* = REVISED SHEETS ADDED AS PART OF CURRENT PLAN REVISION
 ** = TEMPORARY BASIN NO LONGER APPLICABLE. SHEETS REMOVED FROM PLANS

FIRST ADDITION TO 1000 OAKS: STORMWATER MANAGEMENT

CITY PROJECT NO. 11312 CITY CONTRACT NO. 7649 MUNIS NO. 11312

PLAN VIEW
OL 17 - PROPOSED SOUTH WET DETENTION/INFILTRATION BASIN DETAIL

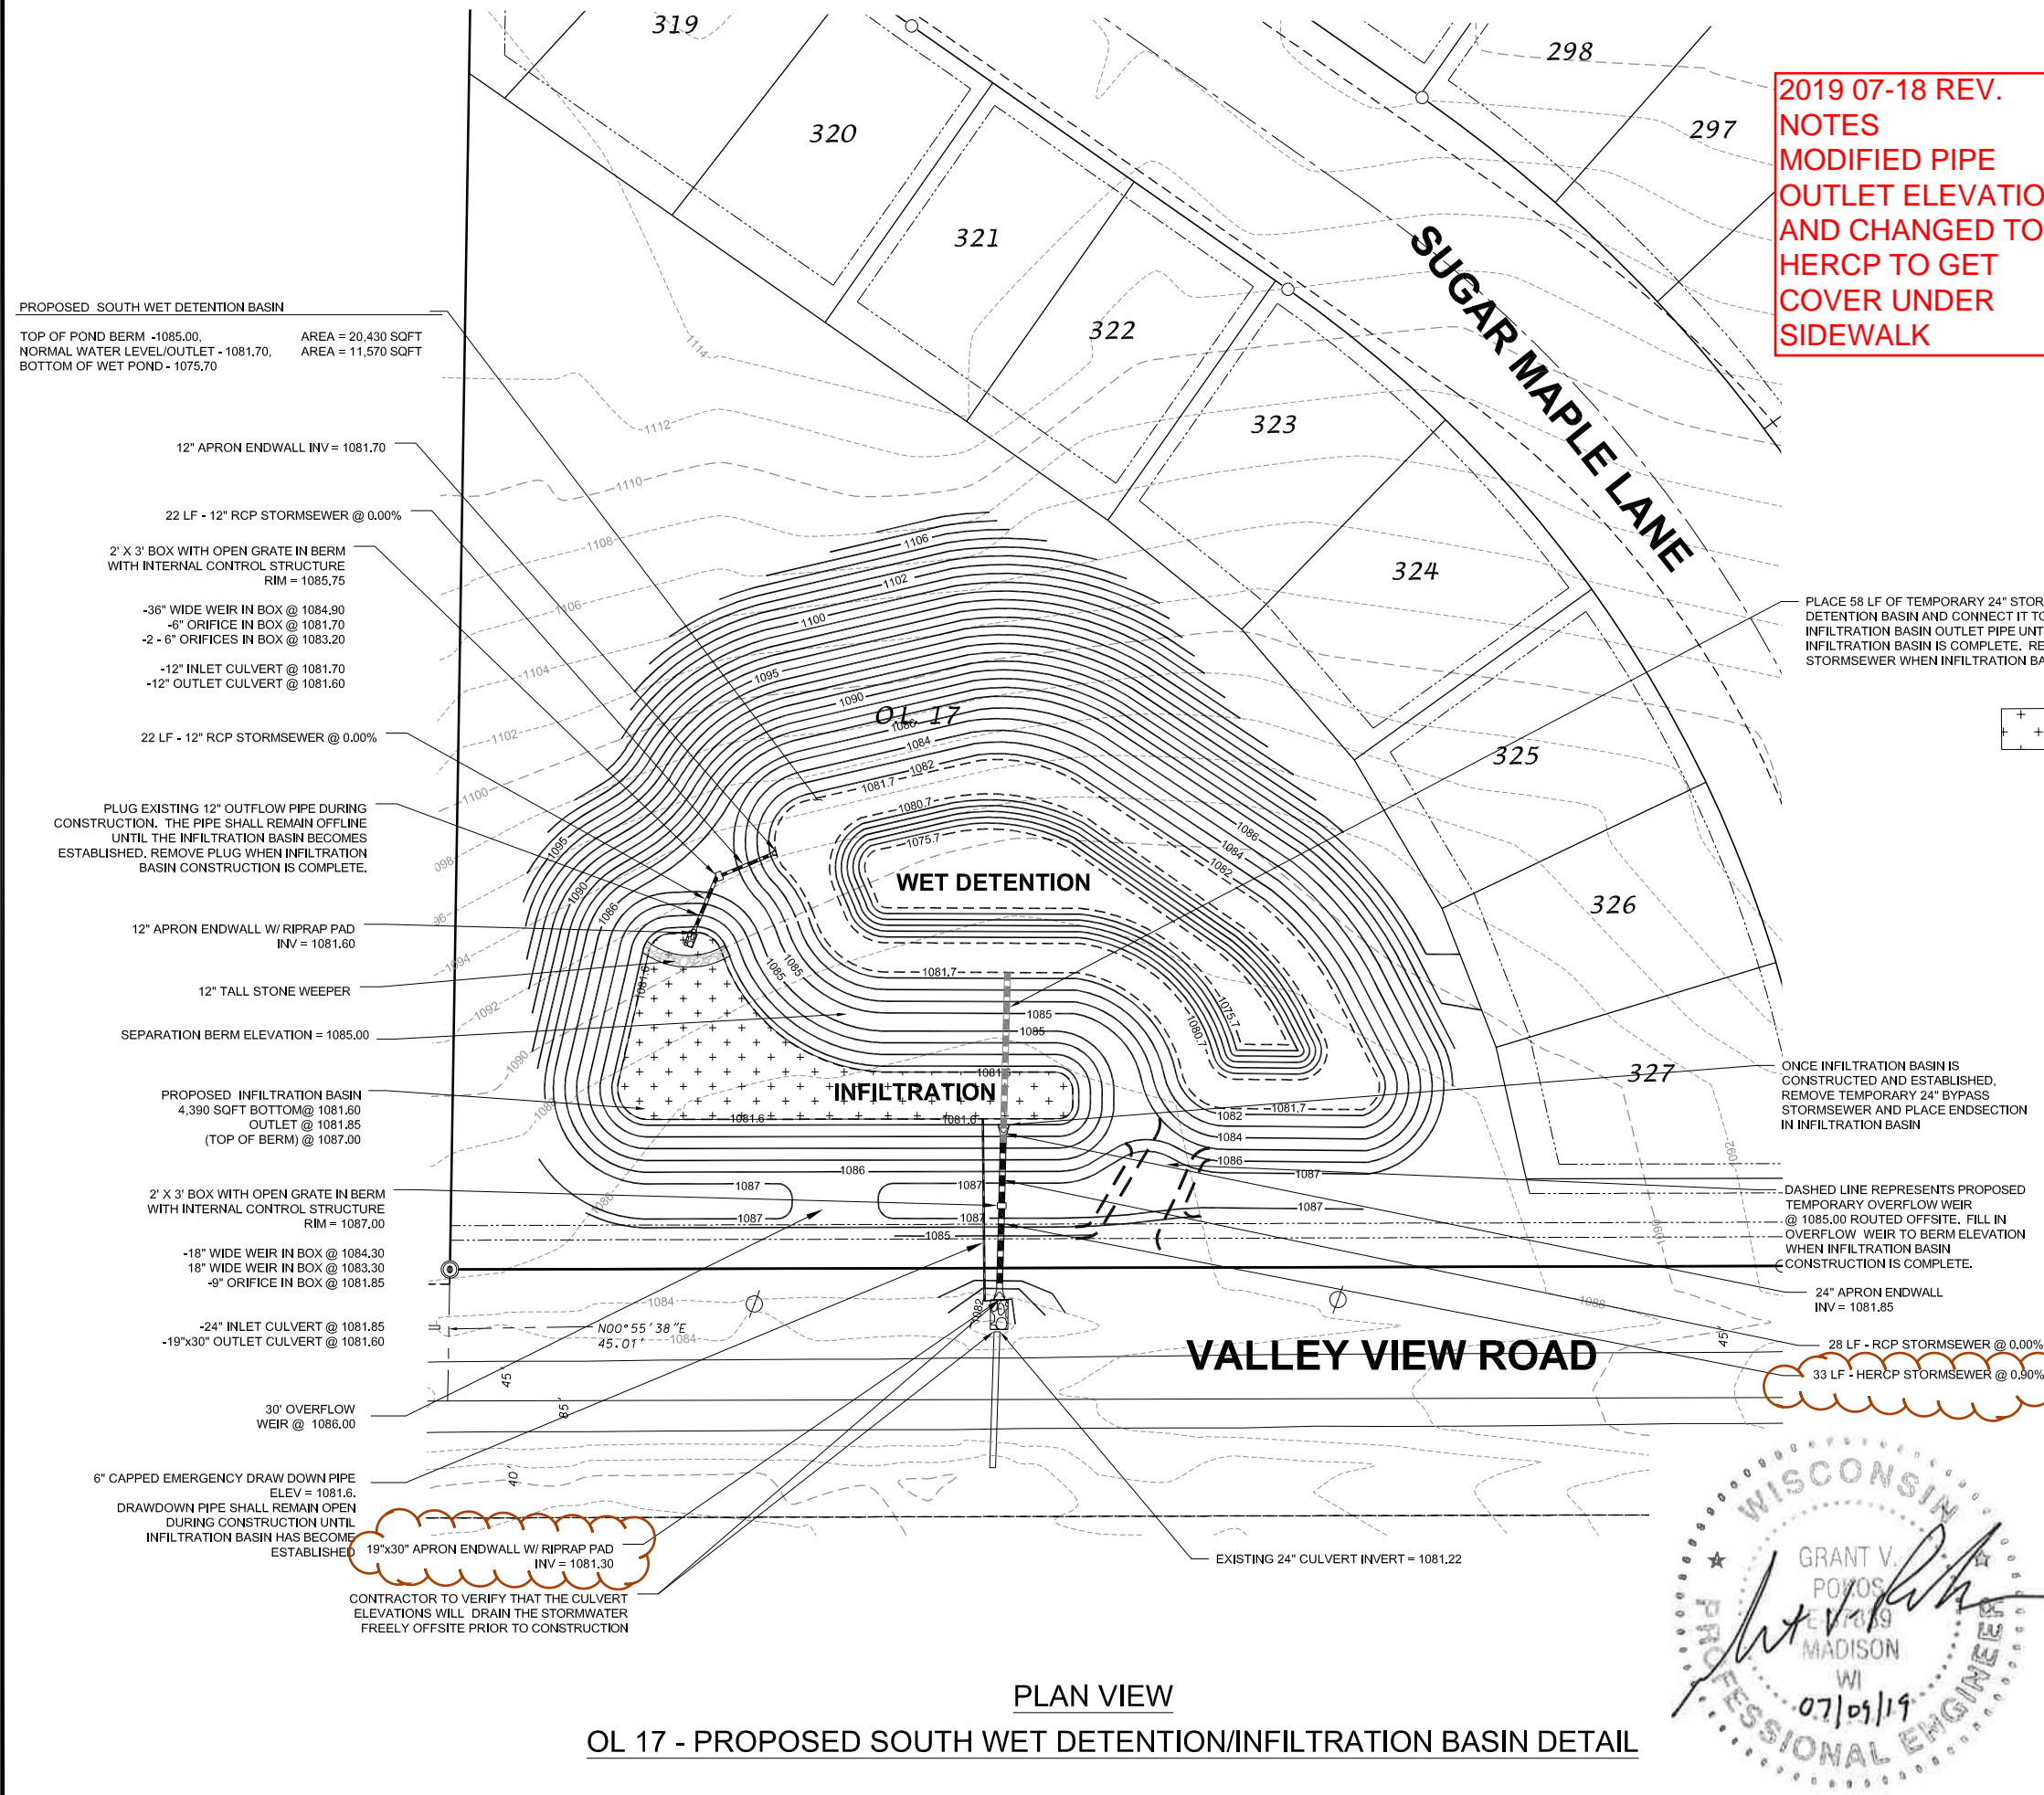
2019 07-18 REV. NOTES
MODIFIED PIPE OUTLET ELEVATION AND CHANGED TO HERCP TO GET COVER UNDER SIDEWALK

PROFILE VIEW
OL 17 - PROPOSED SOUTH WET DETENTION/INFILTRATION BASIN DETAIL
 NOT TO SCALE

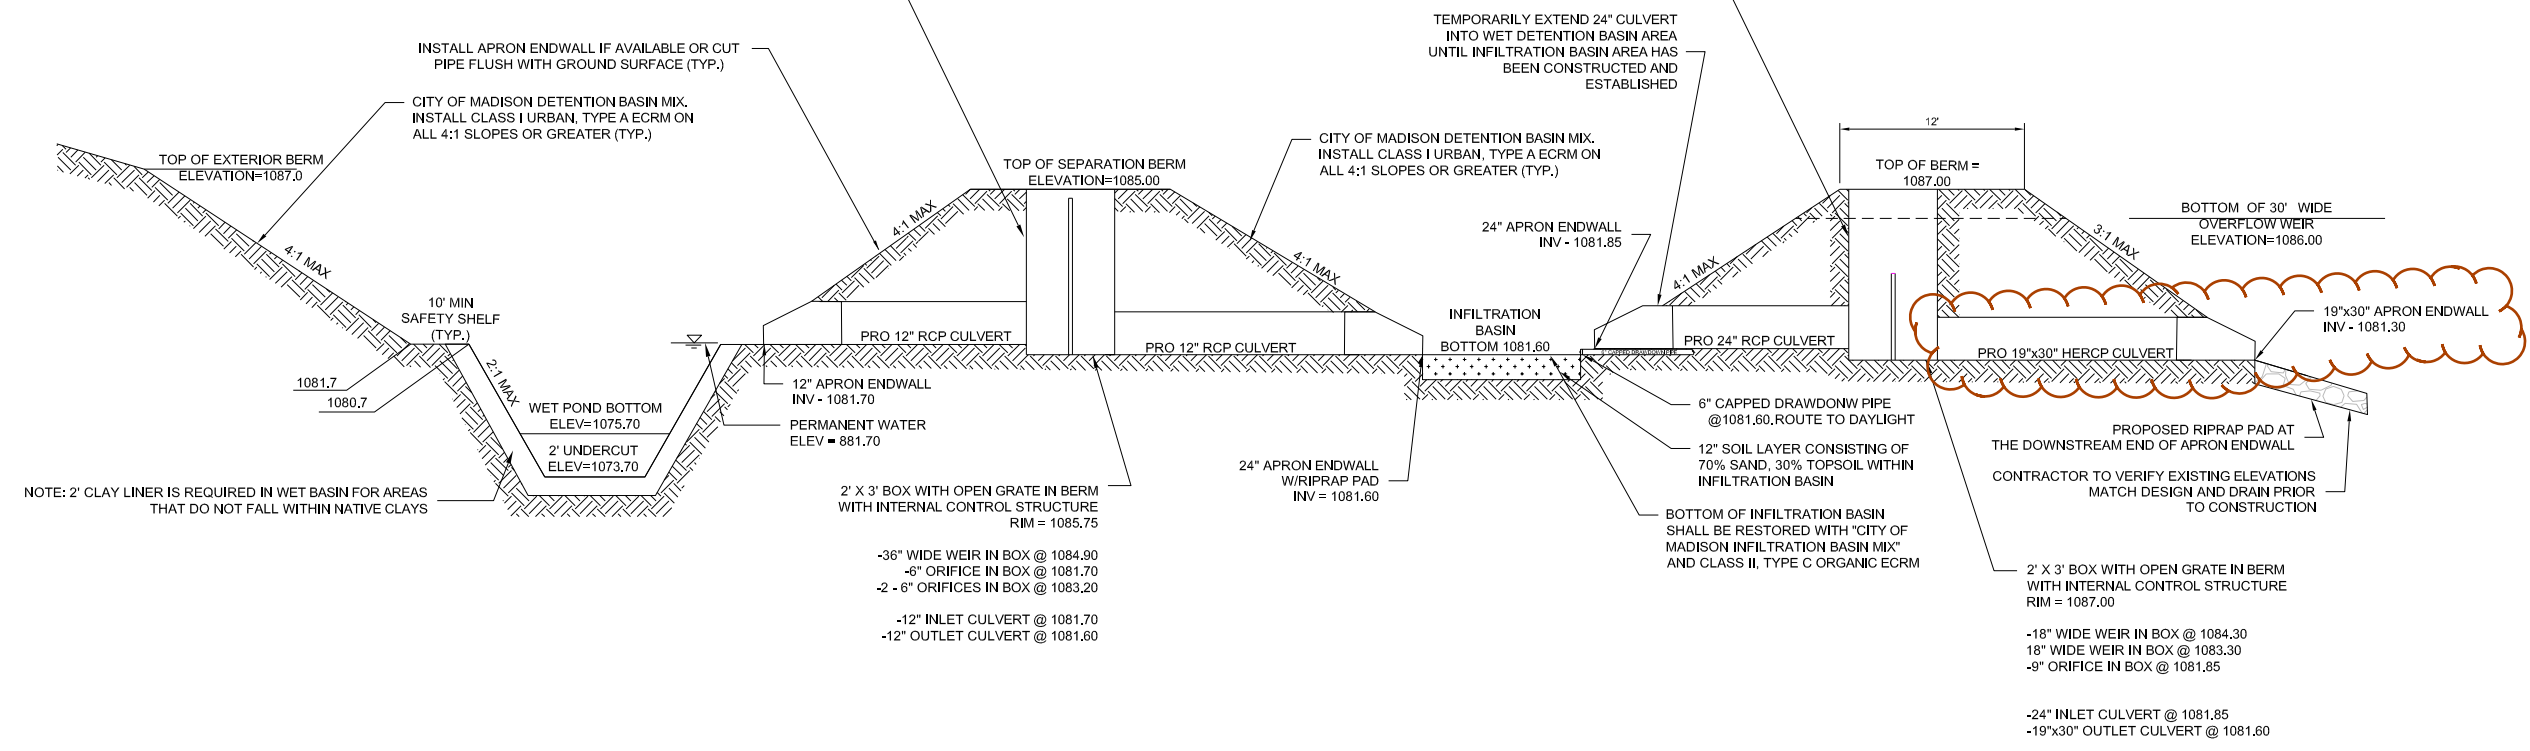
**2019 07-18 REV.
 NOTES
 MODIFIED PIPE
 OUTLET ELEVATION
 AND CHANGED TO
 HERCP TO GET
 COVER UNDER
 SIDEWALK**
